**GDA Close-out for the AP1000 Reactor**

**GDA Issue GI-AP1000-RC-03 Revision 0 – Hydrogen Dosing System**

Assessment Report: ONR-NR-AR-16-046  
Revision 0  
March 2017

**Figure 1: AP1000 Chemical and Volume Control System (CVS)**

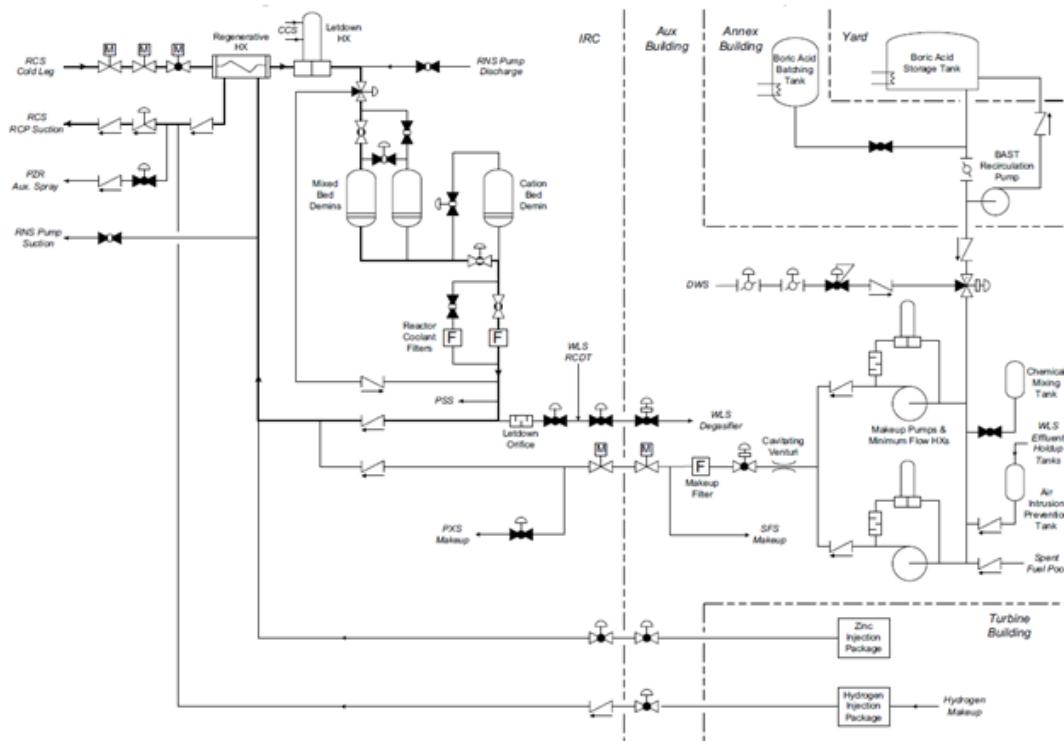
39. As discussed more fully in Ref. 2, the design of the hydrogen dosing system for the **AP1000** design evolved throughout Step 4. The original design was one whereby the hydrogen was added intermittently along with the depleted zinc solution (for dose reduction) through a single line. Adding a liquid and gaseous additive together would create safety challenges and problems in achieving adequate control. In response to ONR concerns, a Design Change Proposal (DCP) for a new hydrogenation and zinc injection system, APP-GW-GEE-1766 (Ref. 15), was submitted in November 2010. It was given the highest UK Level 1 categorisation by Westinghouse following the categorisation scheme operating in GDA. The change was intended to be standard for all **AP1000** plants, worldwide. In summary, the single hydrogen and zinc injection line was separated to add zinc before and hydrogen after the regenerative heat exchanger, as shown in Figure 1.

40. While ONR welcomed this design change as a safety improvement, a number of concerns remained regarding the justifications provided in the DCP. Further information for the new design was requested in TQ-AP1000-1184 and 1230 (Ref. 16), the latter asking specifically for evidence that the proposed system would work as intended. Note that during Step 4 RQs were known as Technical Queries (TQs), but otherwise are the same. Neither response to these TQs fully justified the design of the revised hydrogen injection system, nor provided the expected level of evidence.

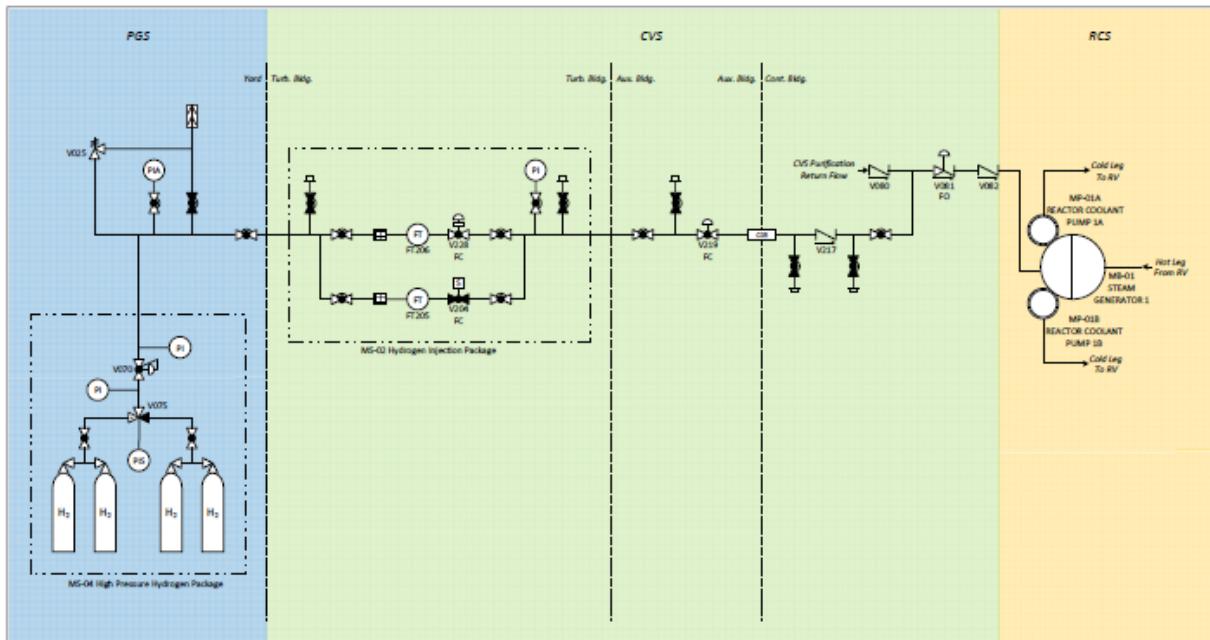
55. As described previously, the hydrogen dosing system is part of the CVS, but it also interfaces with other systems in order to perform its functions, notably the Plant Gas System (PGS) for the hydrogen gas supply and the Reactor Coolant System (RCS) where the gas is injected. The overall system is straightforward and a simplified sketch of the hydrogen dosing system is shown in Figure 2.

57. The piping then enters the turbine building, which contains the hydrogen injection package (CVS-MS-02). Two flow paths are provided through this package; one for 'continuous' (low flow) addition and one for 'batch' (high flow) addition. These two flow paths are necessary to account for the differing demands placed on hydrogen dosing during the different operating modes, discussed further in Section 4.2.4. Various manual isolation valve alignments are necessary to operate the system, but the amount of hydrogen injected is controlled by flow measurements which automatically control the flow rate (in continuous addition) or volume (in batch addition). The addition rates using these two different flow paths are between [REDACTED] and [REDACTED] cc min<sup>-1</sup> for continuous addition, and [REDACTED] cc min<sup>-1</sup> for batch addition (where cc is at Standard Temperature and Pressure (STP)).

58. The piping leaving the hydrogen injection package is then routed through the auxiliary building, before entering containment after passing through the inboard and outboard containment isolation valves. These isolation valves close on receipt of a containment isolation signal, in the same way as other lines that exit containment. The line connects to the CVS coolant return line, which returns the coolant back to the RCS via the steam generator channel head.
